RIDGWAY PLANNING COMMISSION

Tuesday, February 22, 2022

To: Town of Ridgway Planning Commission
Cc: Preston Neill, *Ridgway Town Manager*
From: TJ Dlubac, AICP, *Community Planning Strategies, Contracted Town Planner*
Date: February 18, 2022
Subject: Lot 3 PUD Ridgway Land Company Subdivision Request Evaluation for February 22 PC Meeting

Request: Revised layout, design, and density to approved PUD and Final Plat
Legal: Lot 3 PUD Ridgway Land Company Subdivision
Address: N/A
General Location: East of HWY 550, north of Hunter Parkway, and west of Redcliff Drive.
Parcel #: 430516103010
Zone District: PUD Lot 3, PUD Ridgway Land Planning Company Subdivision - GC General Commercial base zoning
Current Use: Mostly vacant with office building and parking lot at the southwest corner of Lot 3.
Applicant: Joe Nelson and Jack Young, 2 Build Ridgway, LLC
Owner: Rob Hunter, Managing Partner, Ridgway Land Company

FINAL PLAT LOT 3, PUD RIDGWAY LAND COMPANY SUBDIVISION Proposed Site Plan Amendment / Change of Use + Overlay

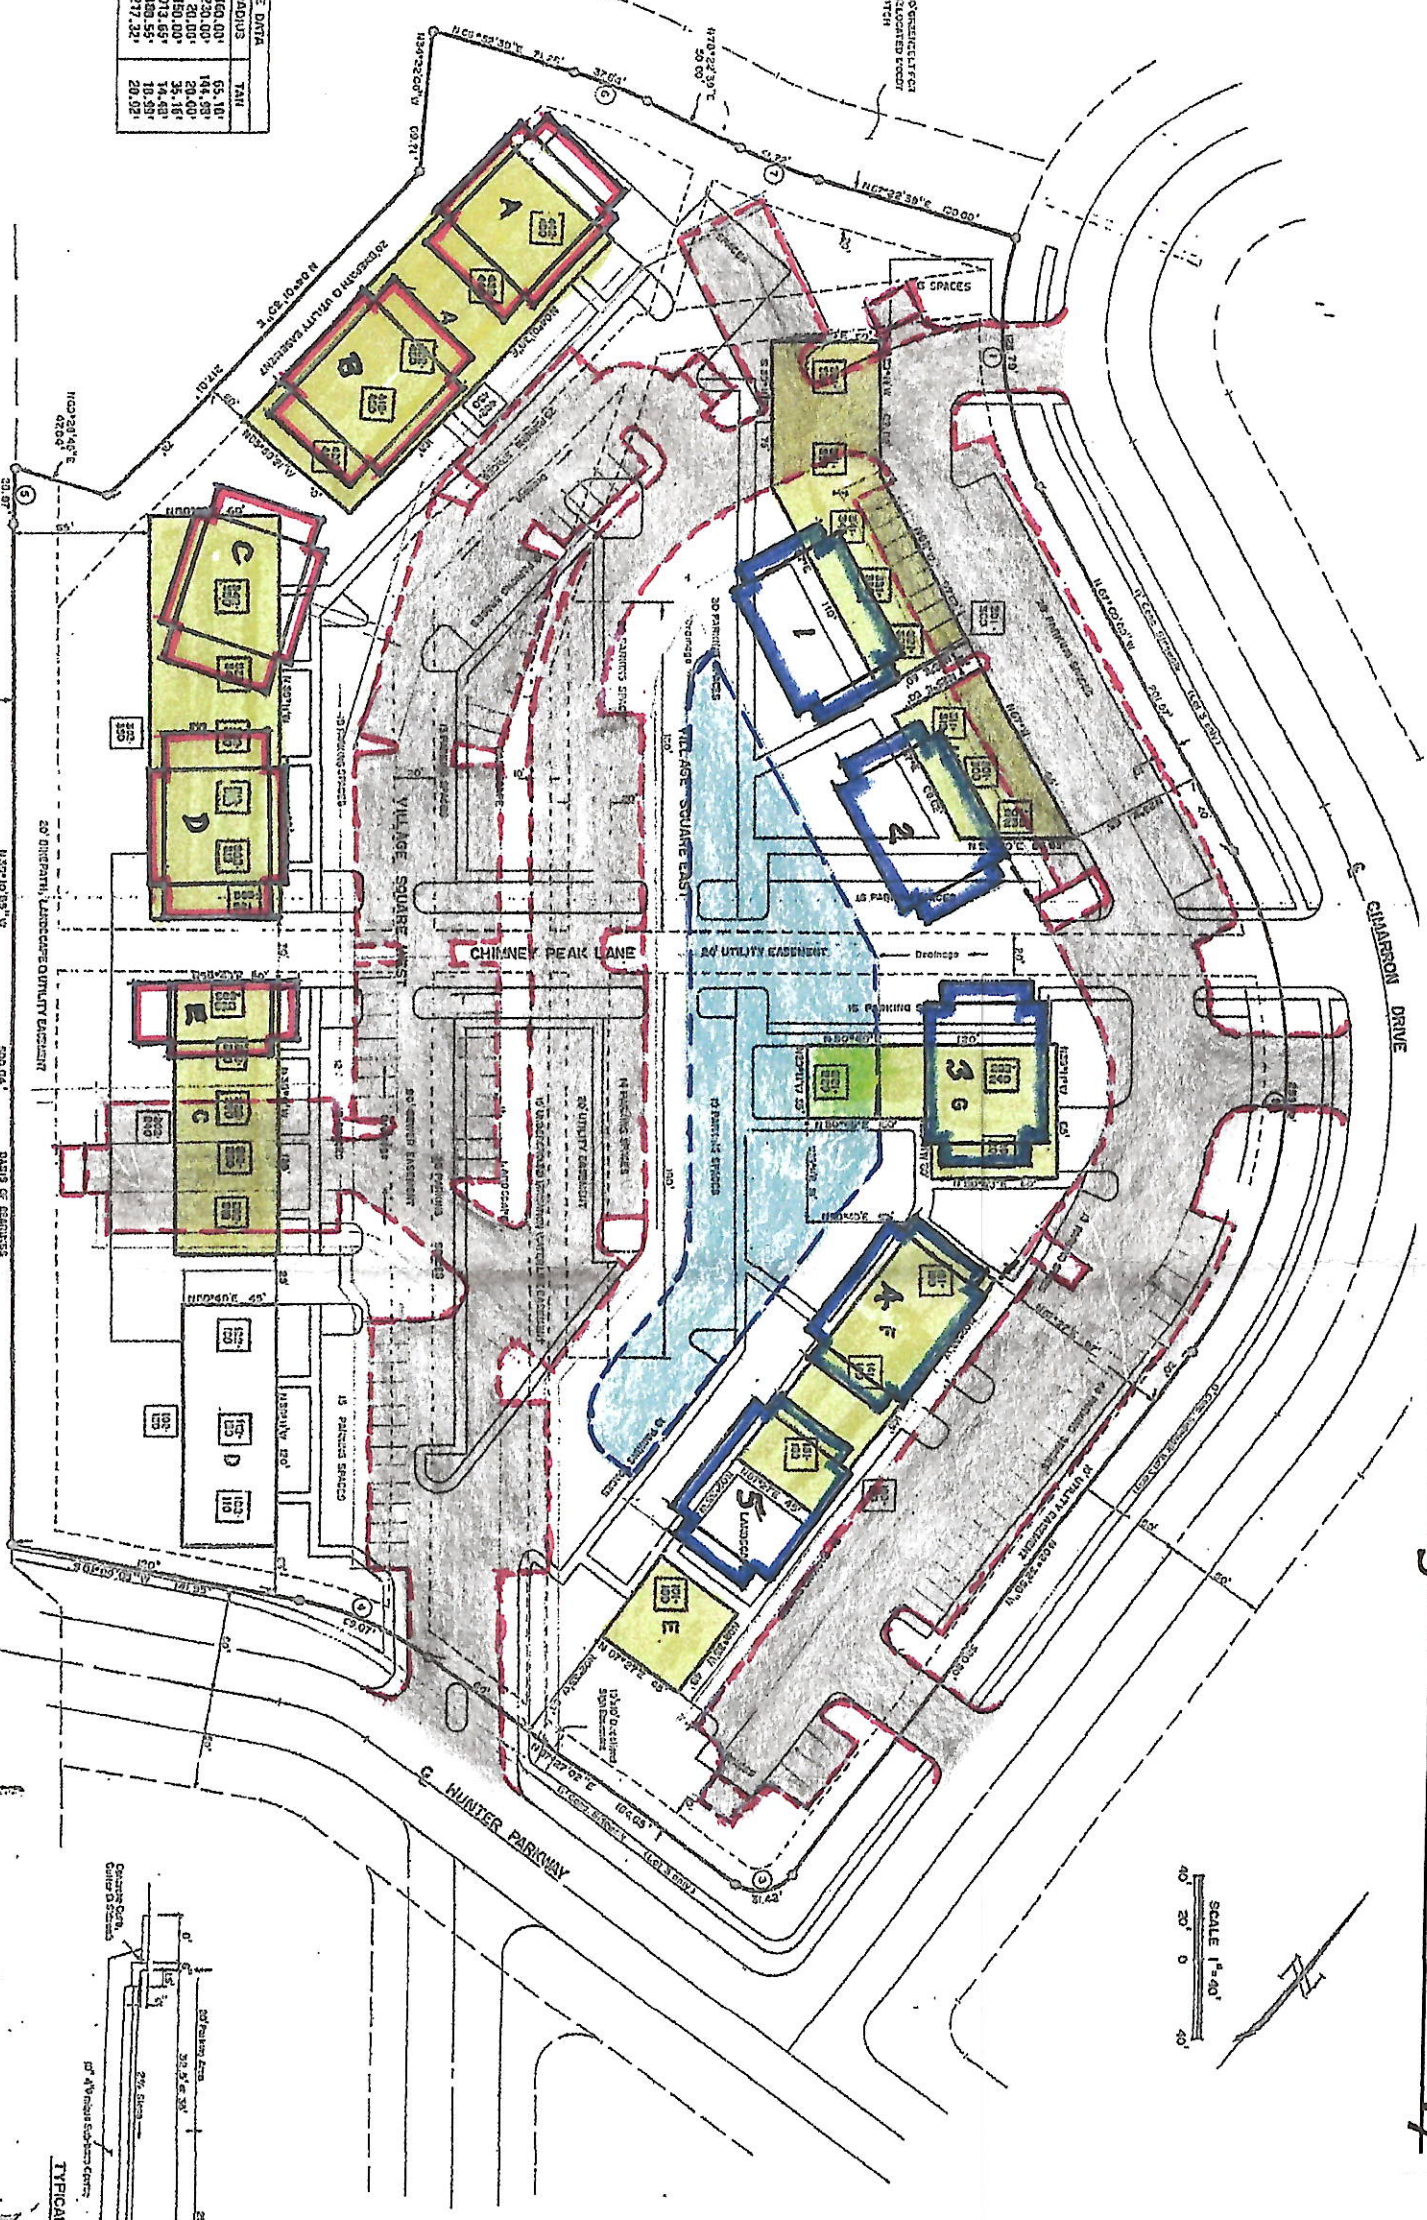
The revisions also remove the internal east-west access lanes and replaces it with what appears to be a pond or water feature. No additional information was provided on this feature or amenity and staff has a number of unanswered questions about this. Topping that list is whether or not there are water rights to keep the ponds full and the need for additional discussion to determine if such a water feature in the Ridgway climate, is the best use of land and water.

- **Building Envelopes:** While the proposed revisions to the building envelopes are generally in the same area as the currently approved building envelopes, there are additional buildings proposed which impacts the overall building footprint/lot coverage and, therefore, the overall site drainage and grading

- **Remax Building:** In all the assessments and analysis provided, the existing Remax Building and associated parking and access is not included. This building is identified as Building D in the original PUD and Building F in the proposed revisions. By removing this building from the analysis provided, the impacts provided do not accurately reflect the existing conditions of the property.

Lot 3 PUD – Westside Apartments

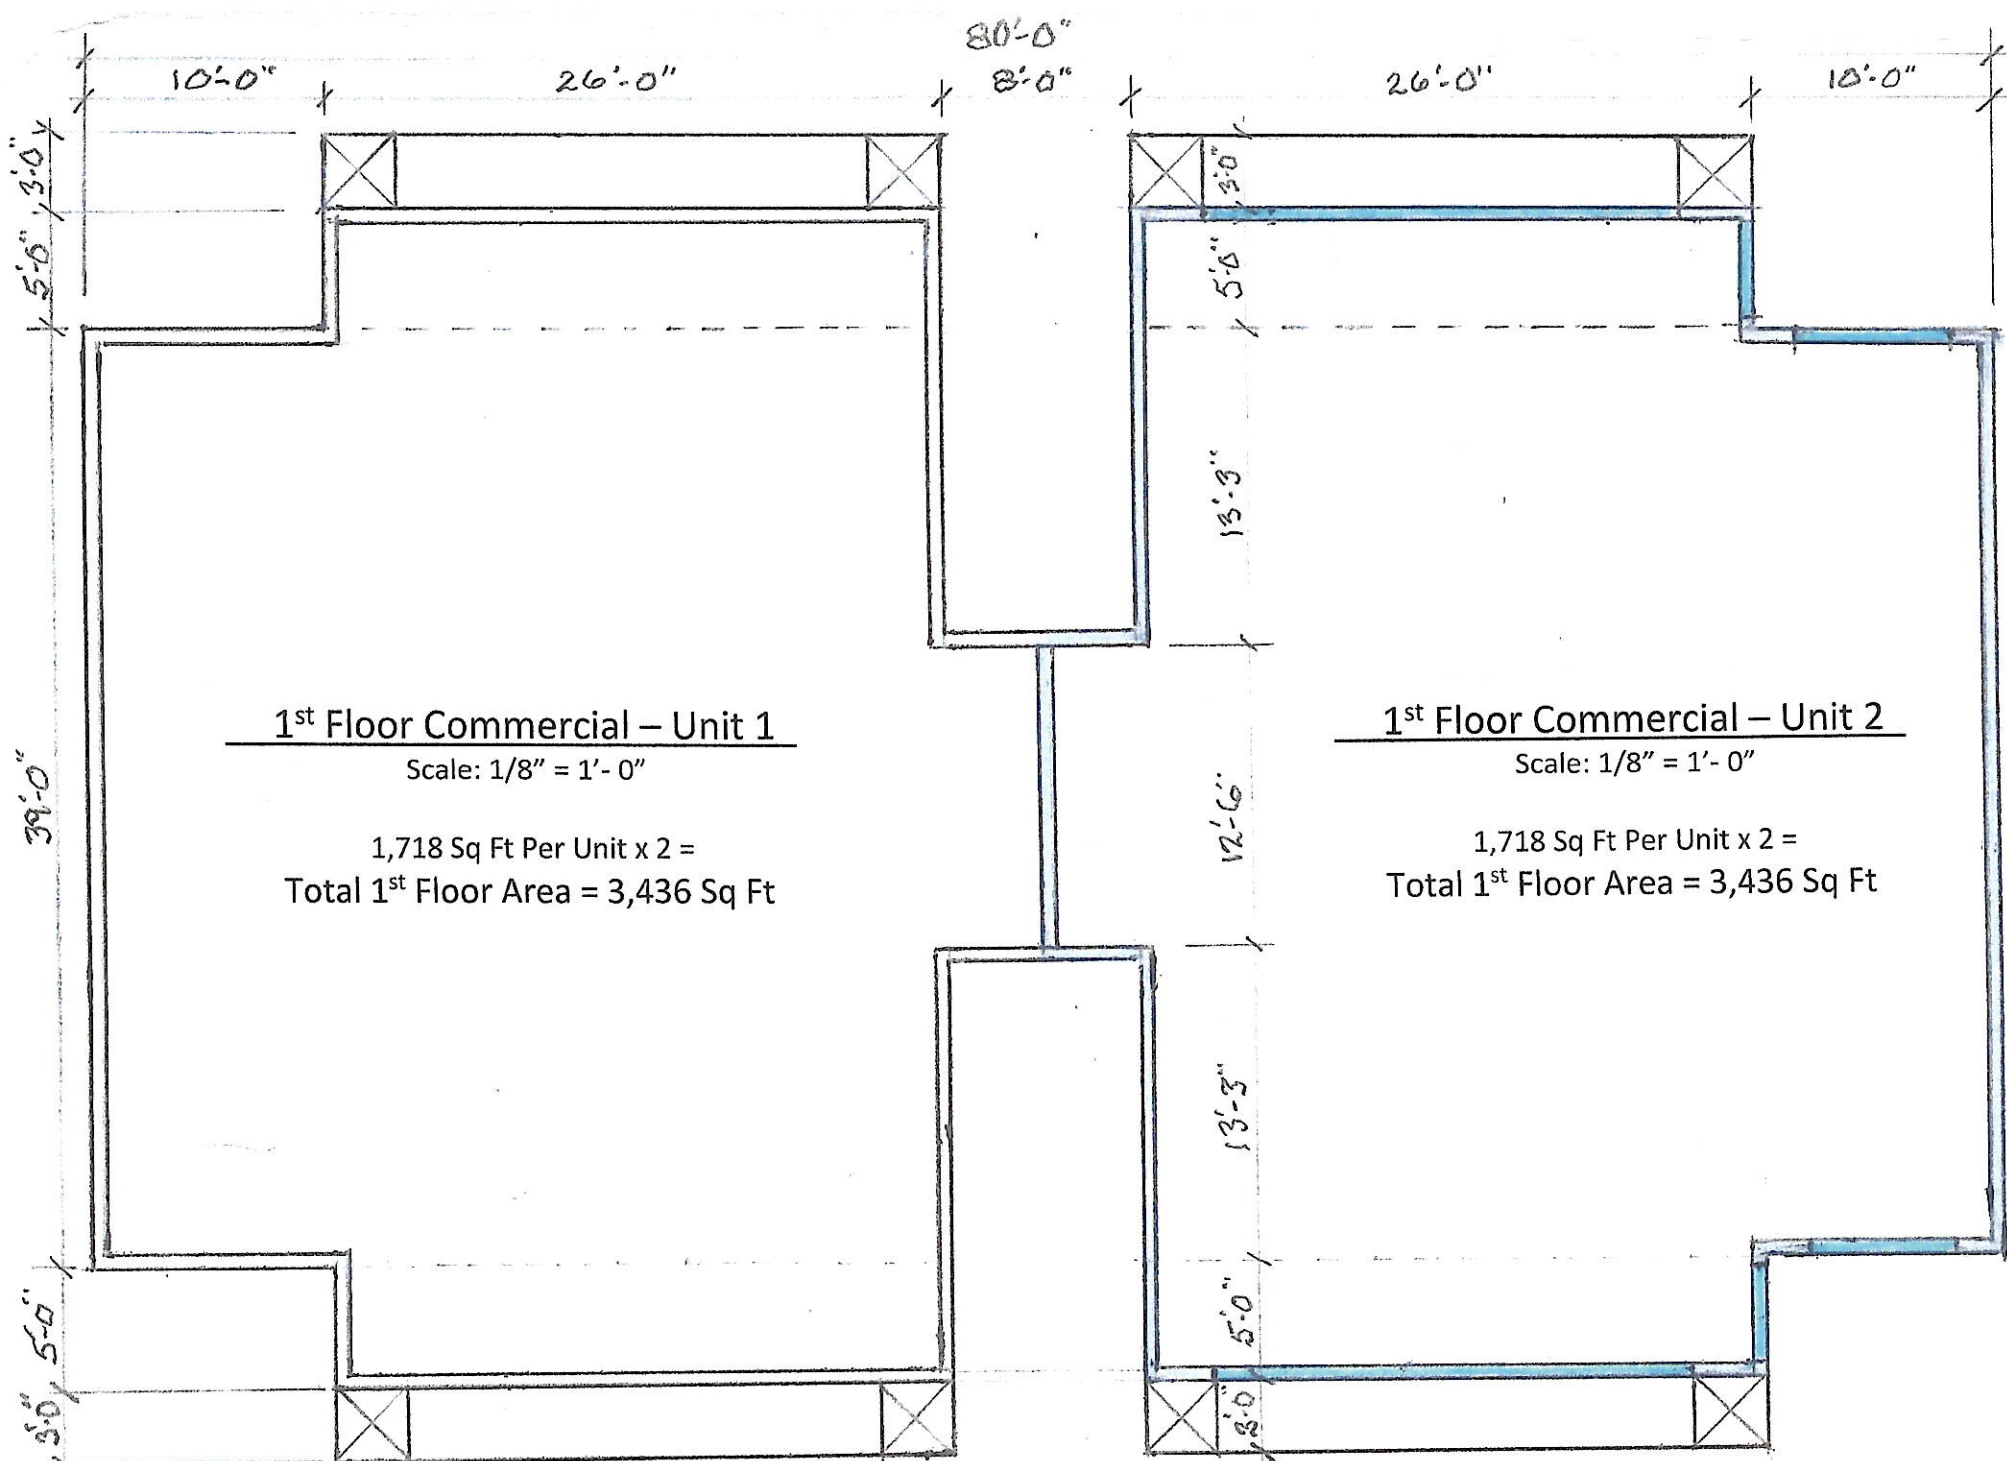
- **Building Height:** The revisions appear to be increasing the building height from two stories to three stories. The GC Zone district allows building heights between 27' and 35' tall to be allowed through a Conditional Use Review. This change in building height should be evaluated pursuant to the RMC provisions and included in the proposed PUD.
